Product Change Notification

1. ECN #: 249483

- USB-B-S-X-X-SM-X-XX

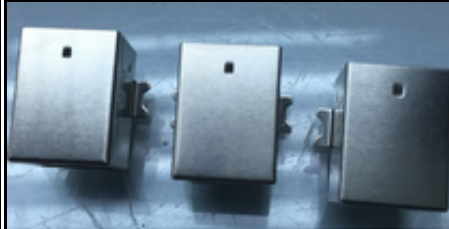
The plating process has been changed from a bright tin finish to Matte tin finish.

The surface finish will change from a glossy finish to a matte finish.

Before Change

After Change

- Form - The part appearance will change from a glossy finish to a matte finish with no other fit or functional issues.
